552-554 CUMBERLAND AVENUE

AP 552 Cumberland Avenue-I

Permit for erection of two wood fire escapes, one on the side and the other on the rear of the building at 552 Cumberland Avenue, is issued herewith based on revised plans received December 11, 1951 but subject to the following conditions:

A check of the plan filed with the application for a permit for construction of wooden fire escapes on the westerly side and the rear of the lodging house at 552 Cumberland Avenue raises the following questions as to compliance with Building Code requirements:

AMENDMENT - To - PLAN

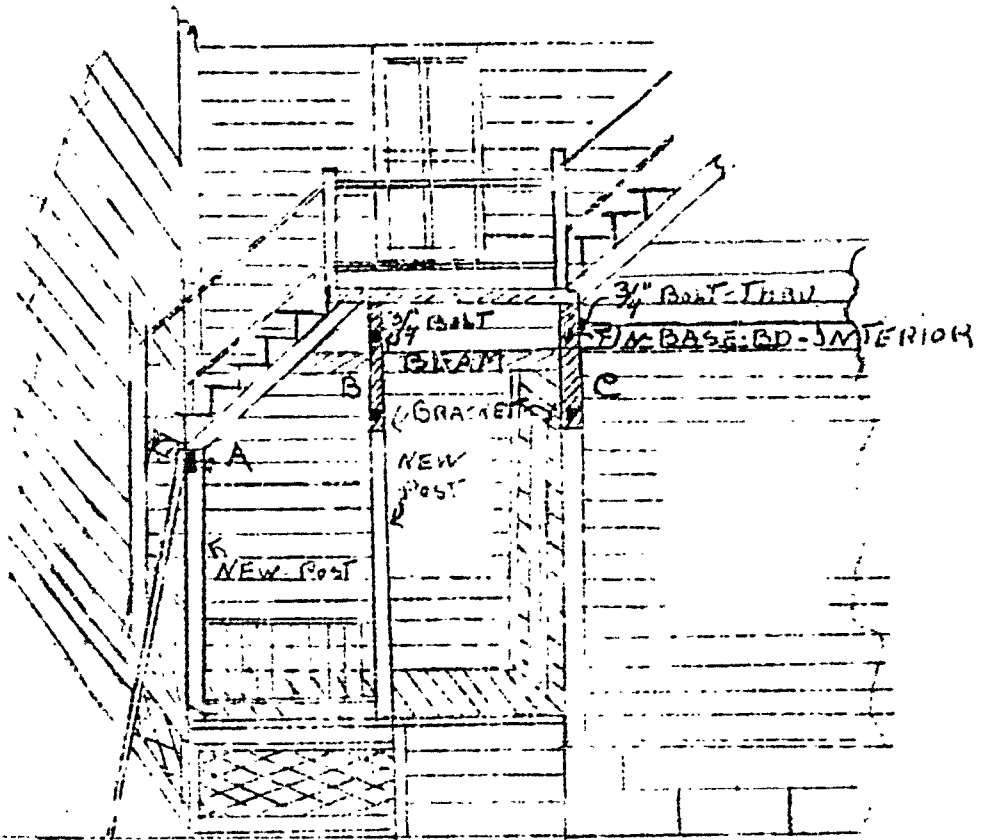
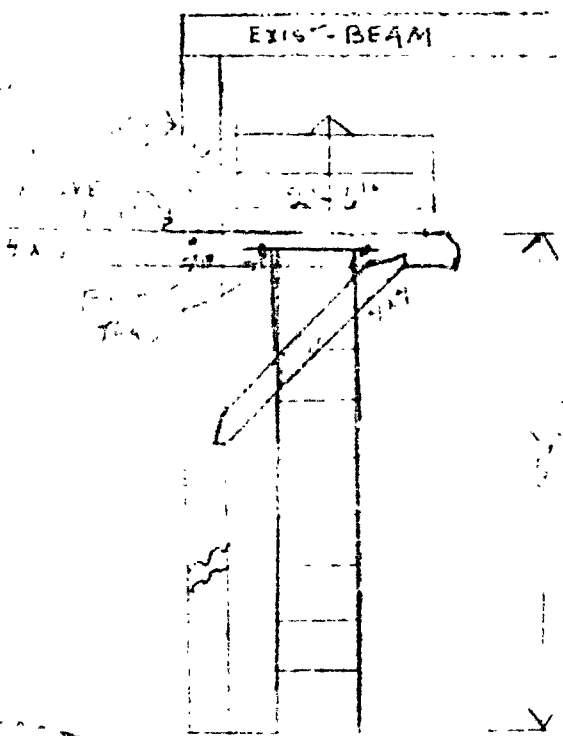
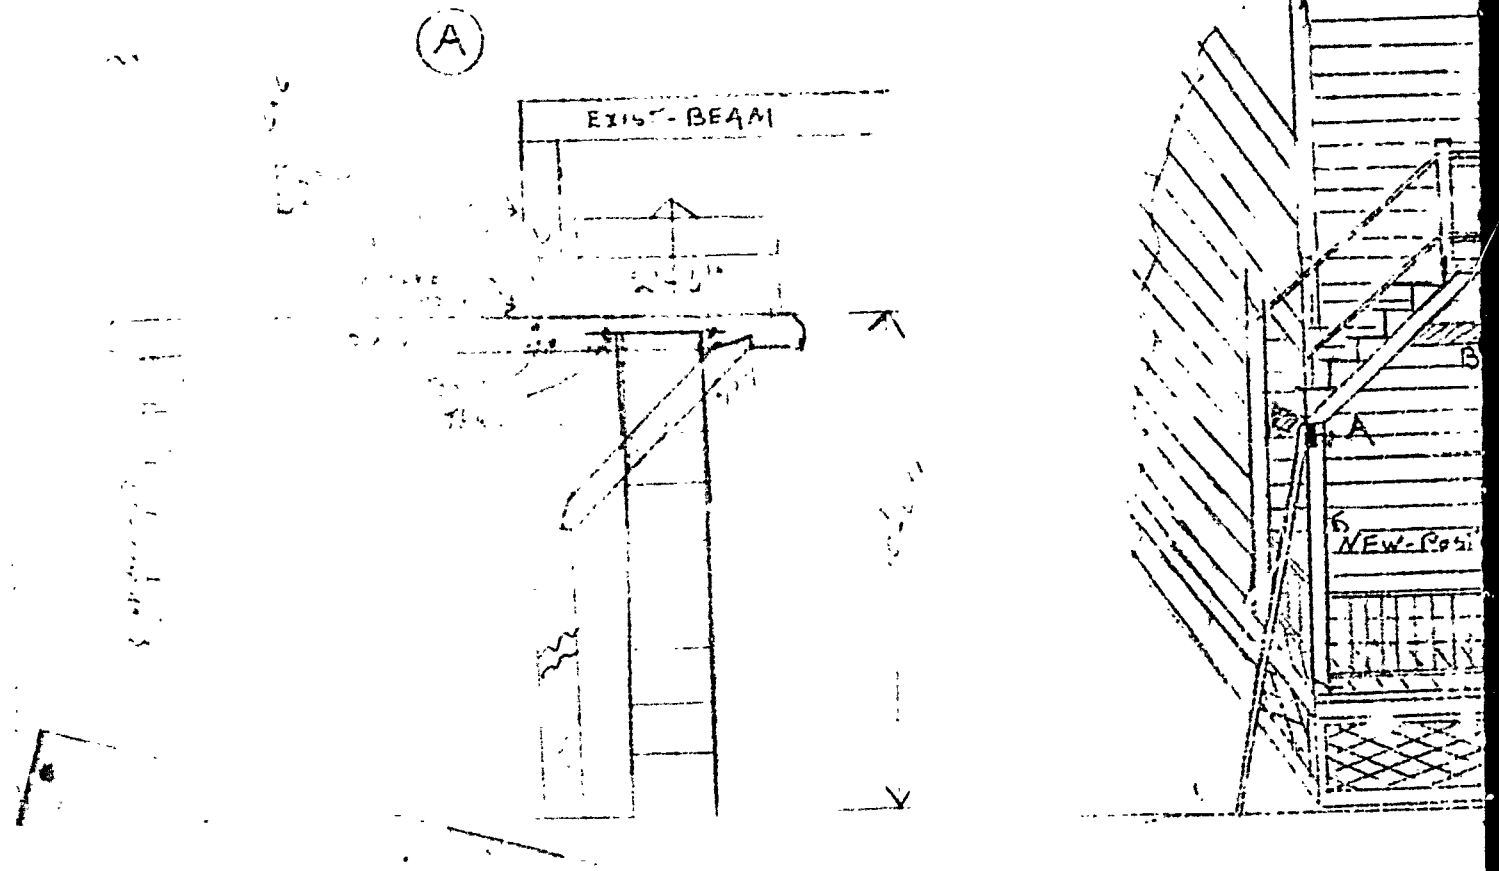
CHANGE - AT - BRACKET

CHANGE - AT - LADDER - BRACKET

1. Through bolts for supporting brackets are required to be not less than 3/4" in diameter instead of the 3/8" diameter bolts shown on the plans.
2. We cannot accept supporting the platform and steps on brackets fastened to the posts of the existing open front piazza, providing adequate construction. Some other method of support will need to be worked out.

3. Brackets carrying the lower landing are to be supported on not less than 3/4" bolts extending through the second story wall of the building above the open piazza in the first story.
